### **Groundwater Transfer Review Summary Form**

Transfer/PA # T- <u>14335</u>
GW Reviewer <u>Steve Ahlquist</u> Date Review Completed: <u>8/6/2025</u>
Summary of Same Source Review:
☐ The proposed change in point of appropriation is not within the same aquifer as per OAR 690-380-2110(2).
Summary of Water Level Decline Condition Review:
☐ Water levels at the original point(s) of appropriation have exceeded the allowed decline threshold defined by conditions in the originating water right.
Summary of Injury Review:
☐ The proposed transfer will result in another, existing water right not receiving previously available water to which it is legally entitled or result in significant interference with a surface water source as pe 690-380-0100(3).
Summary of GW-SW Transfer Similarity Review:
☐ The proposed SW-GW transfer doesn't meet the definition of "similarly" as per OAR 690-380-2130.
This is only a summary. Documentation is attached and should be read thoroughly to understand the basis for determinations.

V	OREGON  WATER RESOURCES DEPARTMENT	Oregon Water Resources Department 725 Summer Street NE, Suite A Salem, Oregon 97301-1271		Ground Water Review Form:		
App	olication: T- <u>1</u

# Theis Drawdown Analysis –Estimated interference at UMAT 2515 from pumping at proposed POA (UMAT 5450) for Certificate 87374 (0.39 cfs/94.2 acre-feet)

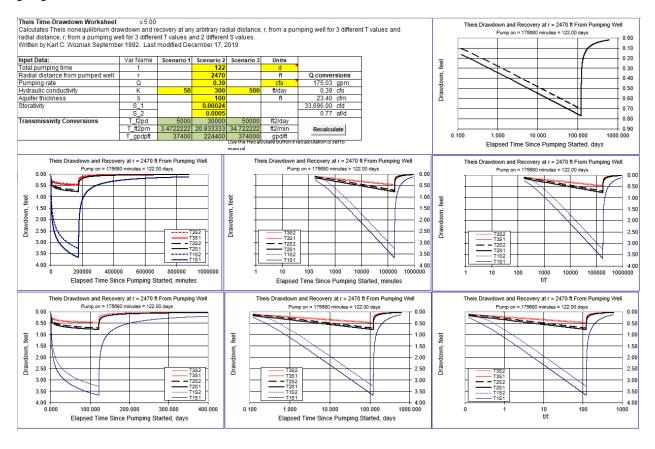
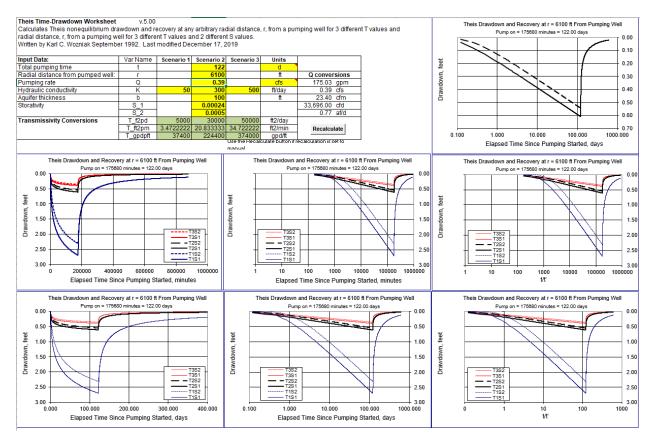
5.	a) Will this proposed change, at its maximum allowed rate of use, likely result in an increase in interference with <b>another ground water right</b> ?					
	⊠ Yes □ No Comments: The proposed POA is approximately 3,630 feet closer to both UMAT 2515 and UMAT 2878 which are authorized POAs on other water rights. The reduced intervening distance will likely result in an increase in interference with these wells.

b) If yes, would this proposed change, at its maximum allowed rate of use, likely result in another groundwater right not receiving the water to which it is legally entitled?					
	Yes No If yes, explain: To assess potential injury at nearby wells due to the proposed use, drawdown from pumping at the proposed POA (UMAT 5450) was estimated using the Theis (1935) solution for drawdown in a confined aquifer (see attached Theis Drawdown Analysis). Model inputs for aquifer properties are from aquifer test data for the basalt aquifers in this area. Results of the Theis analysis indicate that pumping at the maximum authorized rate from the proposed POA (UMAT 5450) would result in less than 1 foot of additional interference at UMAT 2515 and UMAT 2878 and would not result in another groundwater right not receiving the water to which it is legally entitled.
